# APPLICATION FOR APPROVAL TO USE AN EXISTING ON-SITE WASTEWATER TREATMENT & DISPOSAL SYSTEM / WATER SUPPLY WELL

**JOB LOCATION INFORMATION**
TAX PARCEL #: 04512201
STREET ADDRESS: 2235 W SUGAR CREEK
CITY: CHARLOTTE
STATE: NC ZIP: 28262

Re: Application for approval to use an existing on-site wastewater treatment & disposal system.
Property Location: **2235 W Sugar Creek Road**
Health Department File Number: **10464 B**

## PROPOSED PLOT PLAN

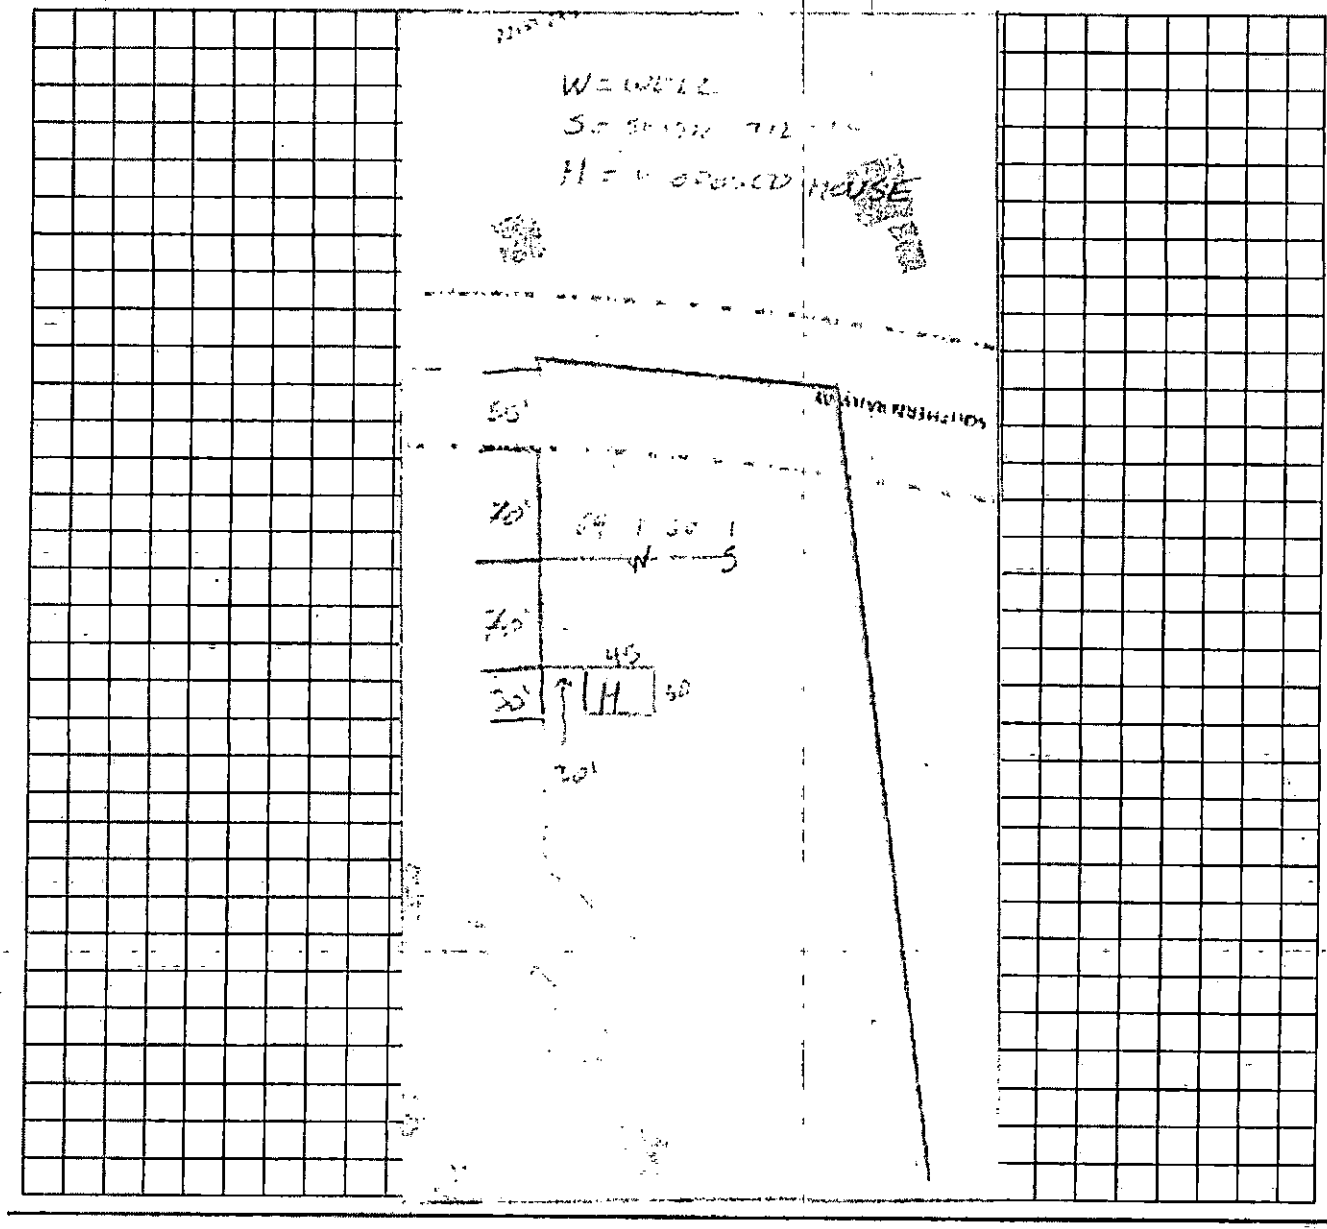
6-bedroom project not approved.

Based on our records, the house that was demolished in 2015, had 3-bedrooms. Since the proposed house will be a 6-bedroom home, we will have to deny the "use existing system" application because the existing septic system is only sized for a 3-bedroom. We could approve a new 3-bedroom home as long as it met the 25' setback off the existing well and the minimum 5' setback off the septic tank and drain field.

If you wish to move forward with a 6-bedroom house, you may apply for an "alteration permit" and we will credit you the $100 that you have already paid toward the $300 alteration permit fee. Once you apply and pay the remaining $200 for the alteration permit we will make a site visit to look at where the existing system is and where additional drain line can be added.

1. Property lines clearly marked to ensure that the existing and new drain lines meet the appropriate setbacks off the property line (10'). We will have to look at the soils on the property to make sure they are suitable for additional drain line and repair area.

2. The existing septic tank and drain field will need to be located and the boundaries of it flagged or marked in some way – a septic contractor can do this for you.

3. Floor plans for the 6-bedroom house emailed to me so we have a copy for the file.

4. The corners of the new house/garage footprint to be clearly staked in the field. The proposed house/garage will need to meet the 25' set back off the existing well and the minimum 5' setback off the septic tank (more if there is a foundation drain).
